SUBJECT: ISSUANCE OF AMENDMENT NO. 29 TO FACILITY OPERATING LICENSE
 NO. NPF-41, AMENDMENT NO. 16 TO FACILITY OPERATING LICENSE
 NO. NPF-51, AND AMENDMENT NO. 4 TO FACILITY OPERATING LICENSE
 NO. NPF-74, FOR THE PALO VERDE NUCLEAR GENERATING STATION, UNITS
 1, 2 AND 3, RESPECTIVELY, (TAC NOS. 66798, 66799 AND 66800)

The Amendments revise Section 6 of the Technical Specifications for each of the three Palo Verde Units to incorporate changes reflecting a revised organizational structure for the Palo Verde plant.

SAFETY EVALUATION BY THE OFFICE OF NUCLEAR REACTOR REGULATION
RELATED TO AMENDMENT NO. 29 TO FACILITY OPERATING LICENSE NO. NPF-41,
AMENDMENT NO. 16 TO FACILITY OPERATING LICENSE NO. NPF-51
AND AMENDMENT NO. 4 TO FACILITY OPERATING LICENSE NO. NPF-74
ARIZONA PUBLIC SERVICE COMPANY, ET AL.
PALO VERDE NUCLEAR GENERATING STATION, UNIT NOS. 1, 2 AND 3
DOCKET NOS. STN 50-528, STN 50-529 AND STN 50-530

OFFSITE ORGANIZATION
Figure 6.2-1

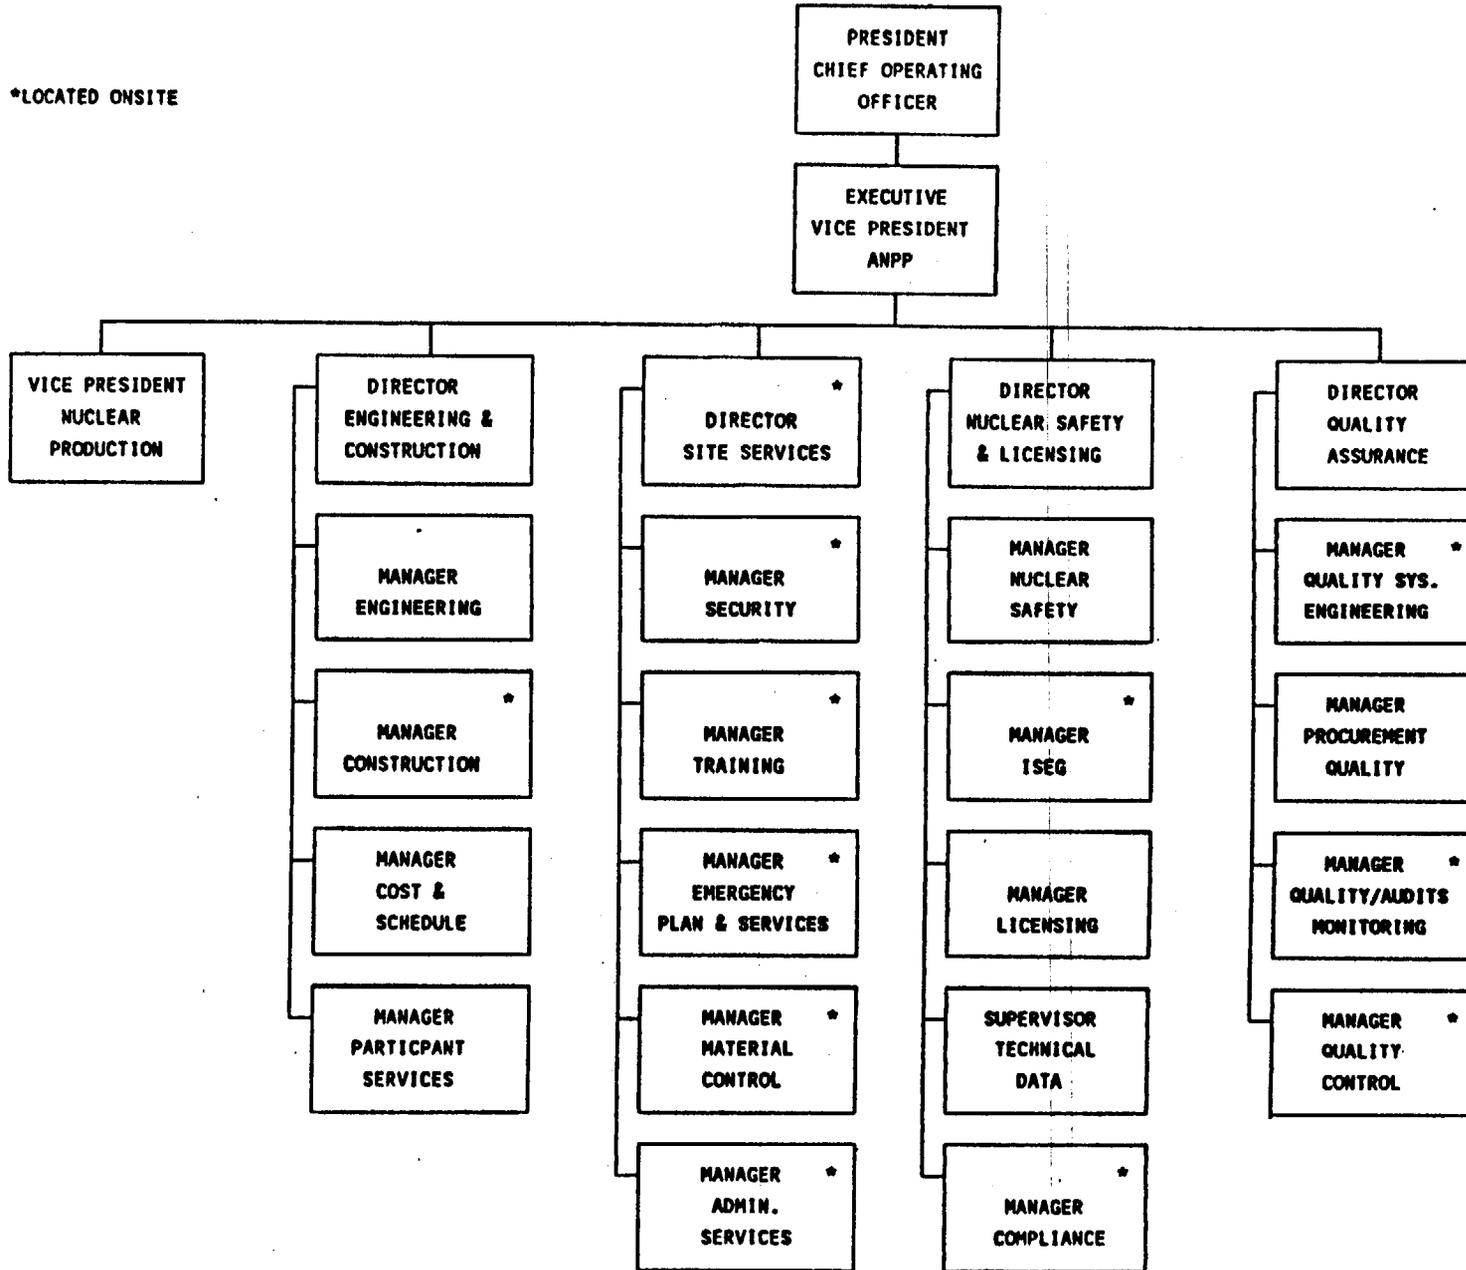
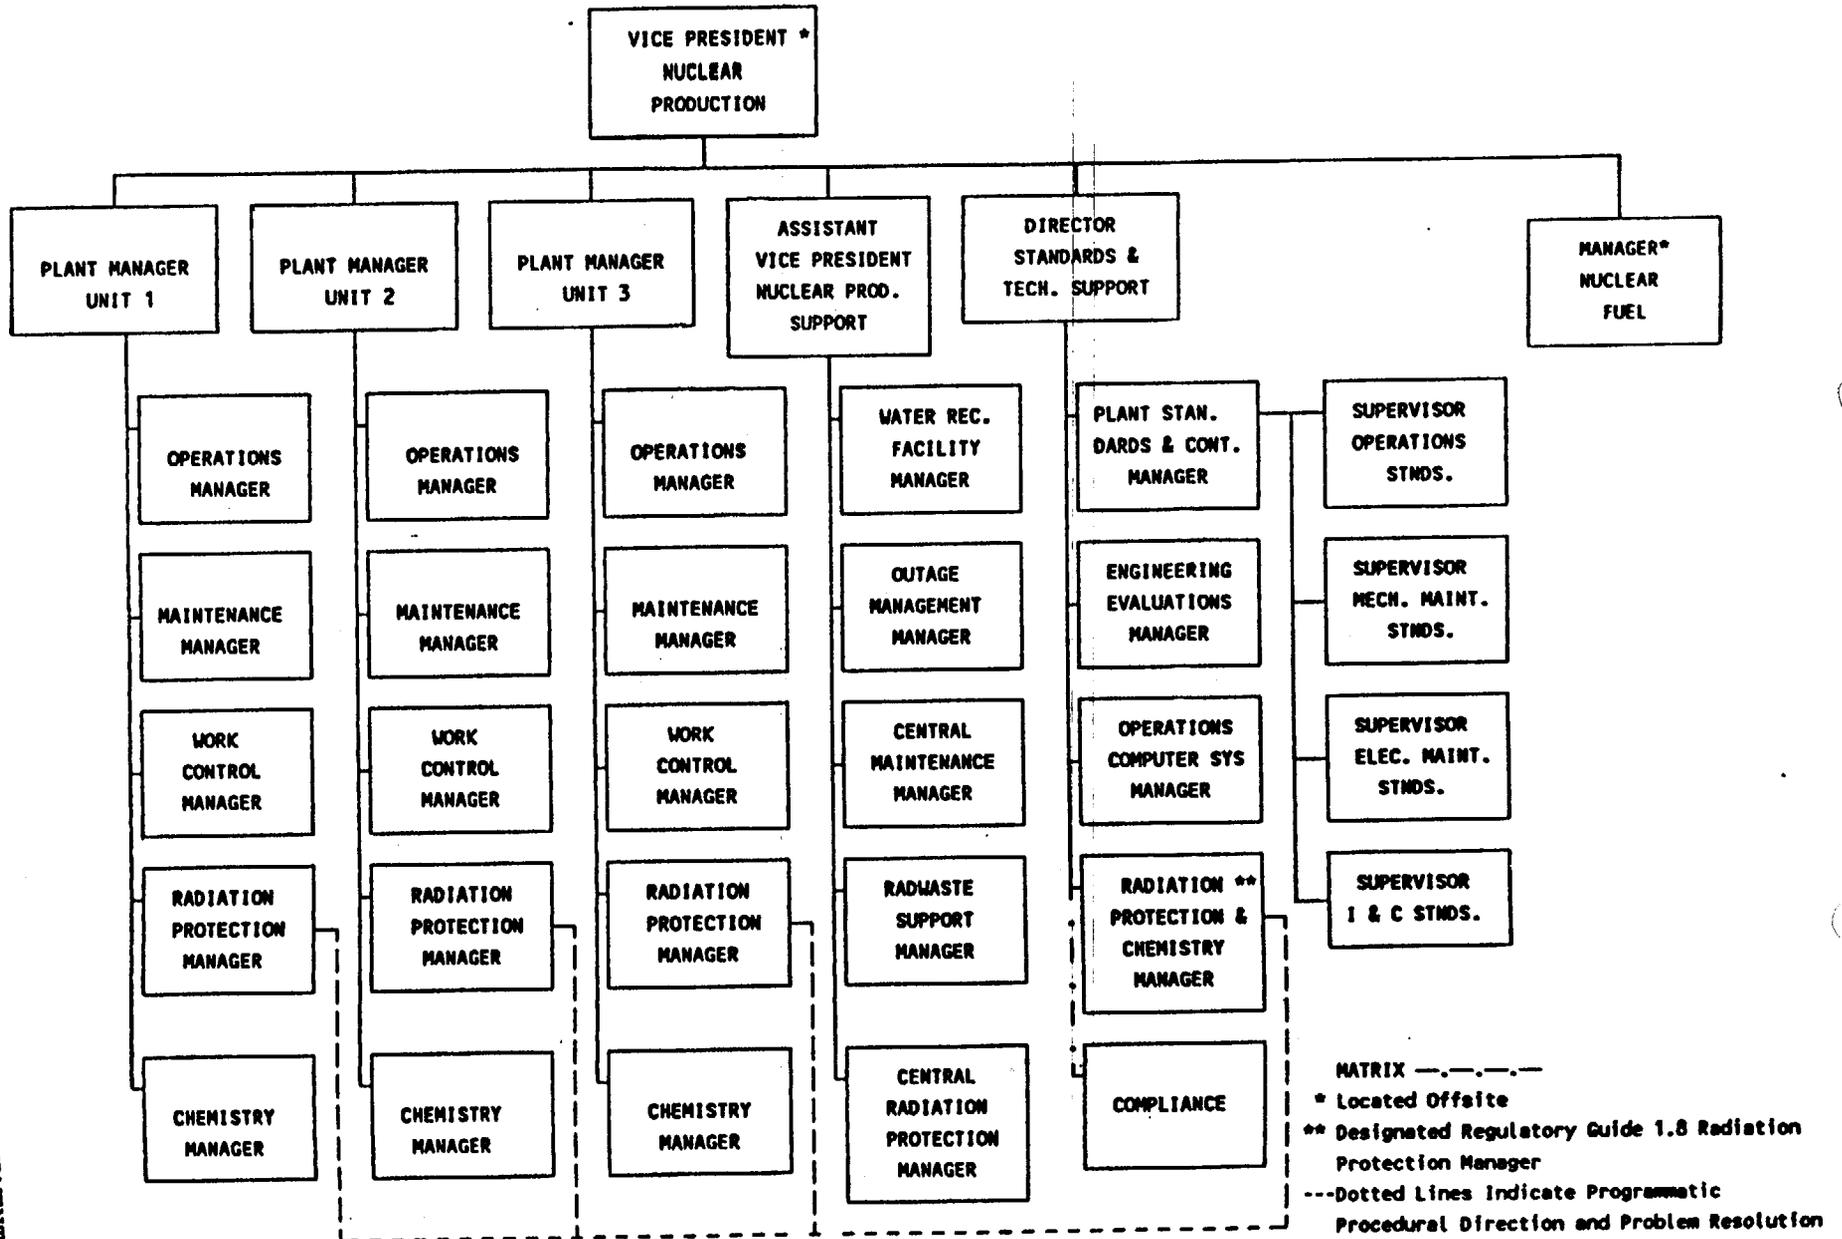
The proposed change requests an amendment to the Palo Verde Units 1, 2 and 3 Technical Specifications, Section 6, Figures 6.2-1 and 6.2-2, "Offsite Organization" and "Onsite Unit Organization." The change is administrative in nature in that the Manager of Nuclear Fuels will now report to the Vice President of Nuclear Production in lieu of reporting to the Director of Engineering and Construction. The change is intended to facilitate communications between the management of the Arizona Nuclear Power Project and the nuclear fuel supply vendor.

The staff has evaluated the proposed change and finds that the change should enhance management effectiveness with regards to fuel management. The Nuclear Fuels Department is responsible for fuels management and core analysis for the Palo Verde Units. The Manager of Nuclear Fuels provides nuclear fuel design, contracting and utilization expertise, nuclear fuel core and plant transient and accident analysis, and alternative core operating strategies. The areas of responsibility will remain the same.
